RE: Town of Swiss CUP #: CUP-20-47

The Burnett County Conditional Use Permit (CUP) Application #CUP-20-47 is incomplete and inaccurate according to the Burnett County Conditional Use Permit Application document (Application) and therefore cannot be sufficiently reviewed by the Land Use and Information Committee (LUIC).

Enclosures: Exhibit A – Campground Conceptual Plan Site Count

# CONCEPT SITE PLAN: FOR NORTH CAMP NELSON ROAD CAMPGROUND

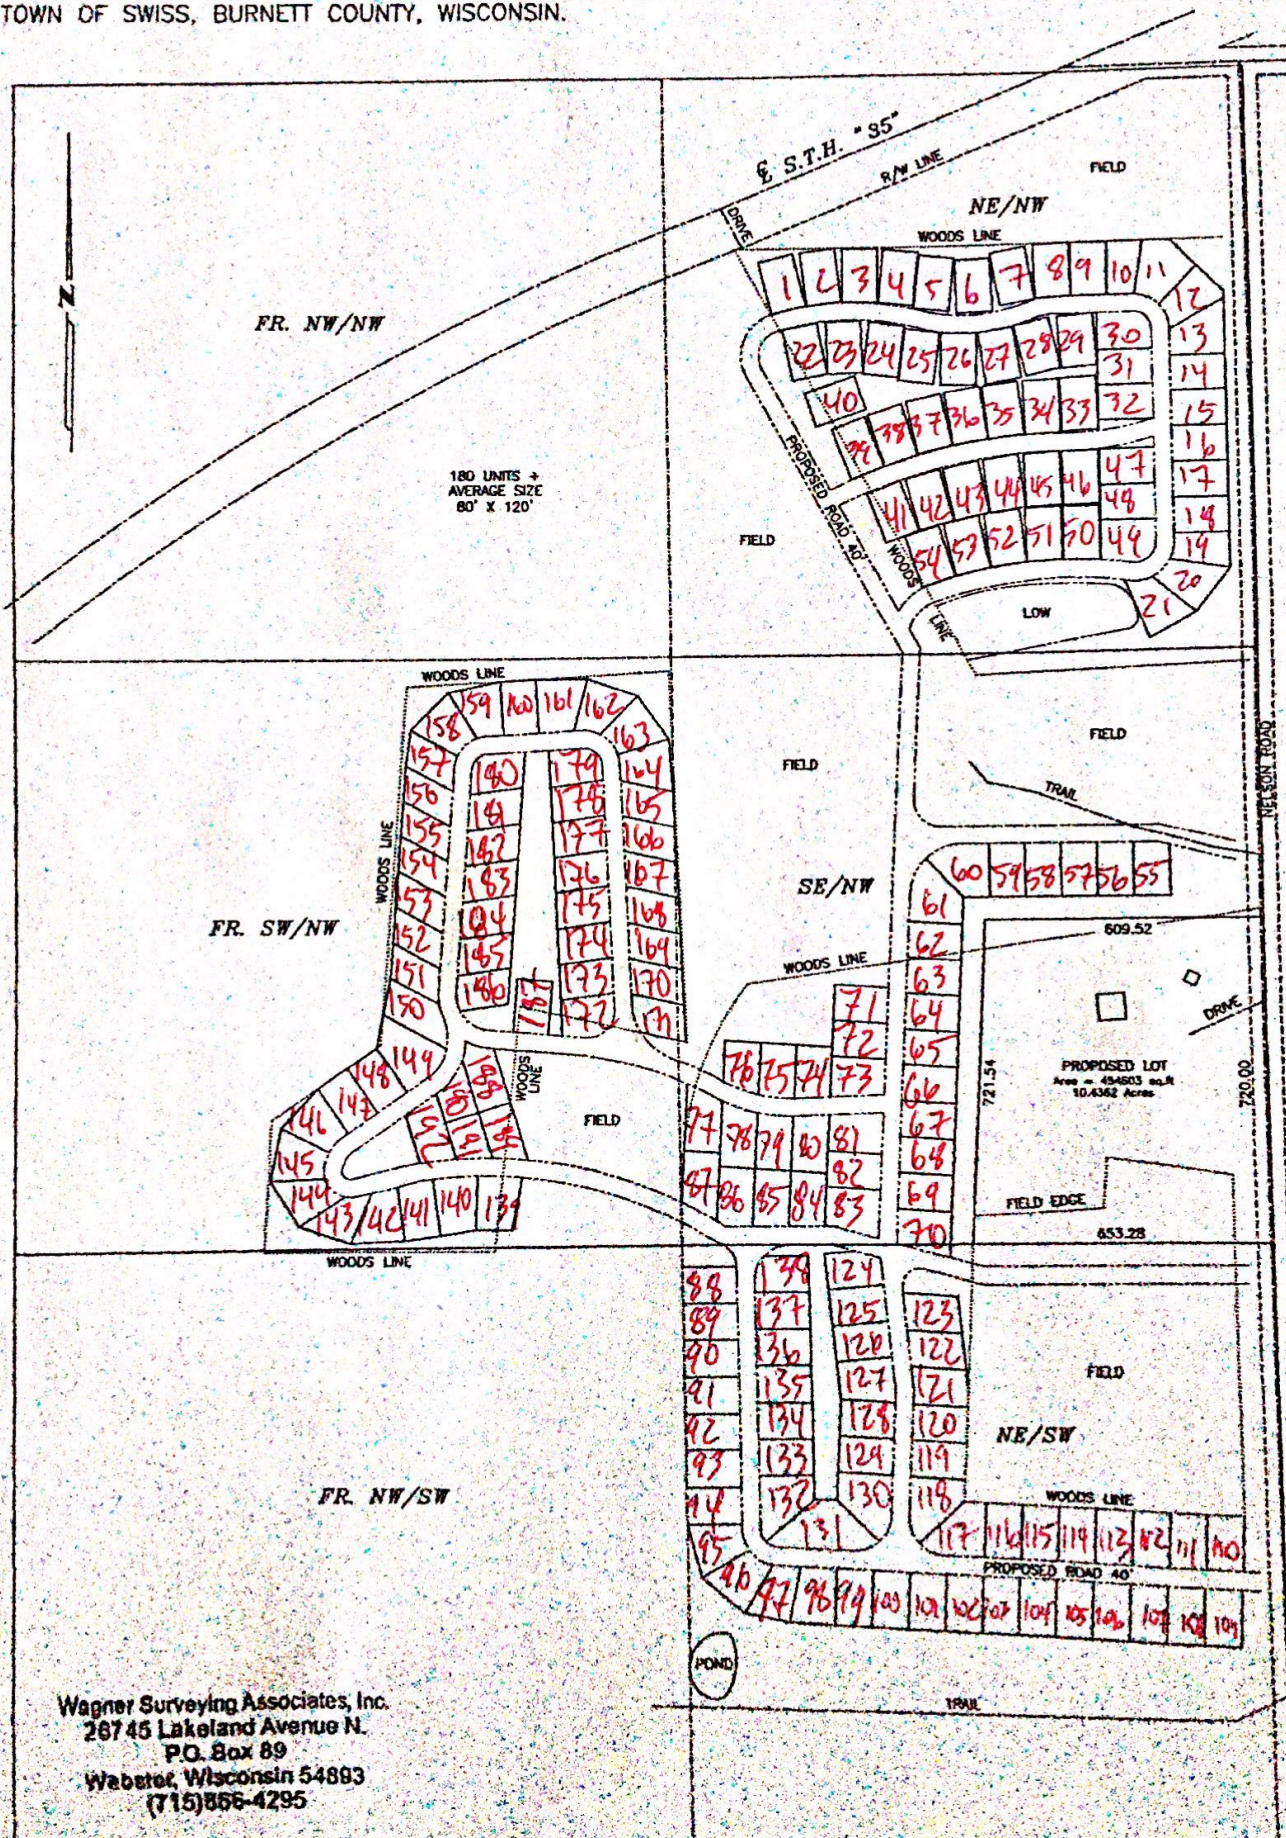
- 1) There is a discrepancy in the proposed number of campsites listed in the CUP application (180) and those drawn by Wagner Surveying on the submitted conceptual plans (192) (See Exhibit A). This discrepancy should be resolved.
- 2) According to the Application, the plot plan drawing should show "dimensions, locations and setbacks of all existing and proposed structures including all decks/porches/walkways/etc;...".

The Applicant notes that a restaurant / bar and event center is proposed, however the restaurant / bar and event center are not drawn on either of the conceptual plans submitted with the Application. Further, no structures accessory to campground operations (eg. storm shelters, offices, etc.,) are noted or shown.

- 3) According to the Application, the Applicant's plot plan should show "property lines, road right-of-ways, and road centerlines including distances to property lines, road right-of-ways and road centerlines for all existing and proposed structures on the parcel". Neither conceptual plan submitted shows how the campground access road will intersect with Nelson Road. Further, none of this information has been provided for the proposed restaurant / bar and event center.

- 4) The Applicant notes they will “split house and barn area 10 acres for restaurant / bar and event center”. According to the Applicant’s conceptual plans, this area is noted as 10.4362 acres. This discrepancy should be resolved. To review an Application that contains multiple campsites with an average area of 9,600 square feet, or 0.22 acres, appropriate accuracy should be employed throughout.

- 5) According to the Application, the Applicant’s plot plan drawing should show “sanitary system, drainfield and well with distances to property lines, OHWM, wetlands, floodplains, existing and proposed buildings”. The Applicant has provided no sanitary, drainfield or well information in writing or in their proposed conceptual plans.

# Surface Water Data Viewer Map

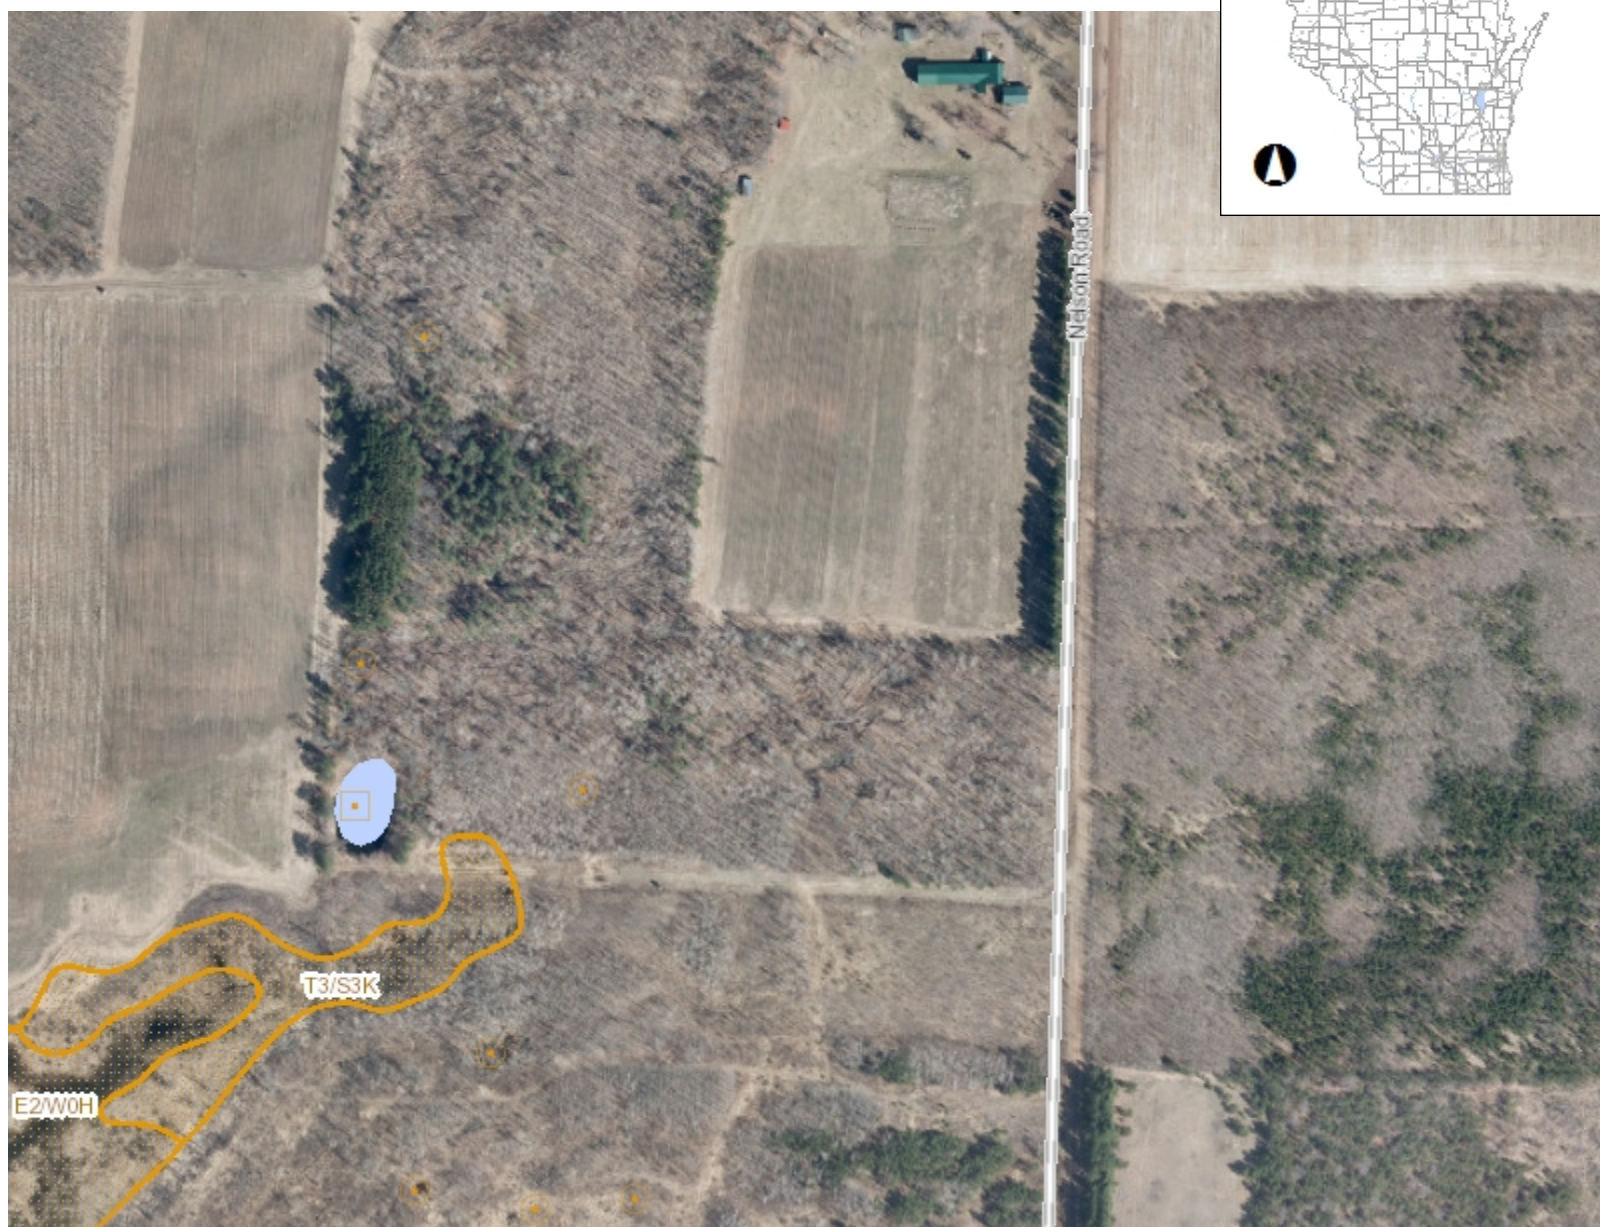
- 6) According to the Application, the Applicant’s plot plan drawing should show “floodplain and wetland boundaries and distances to them from all existing and proposed structures”. The Staff Report notes: “According to the WI DNR wetland map there are some wetlands on the parcel described as the NE-SW”. These wetlands are potentially within 200 ft of proposed campsites in this parcel and, excepting the pond, are not shown on either of the submitted Conceptual Plans (See Exhibit B).
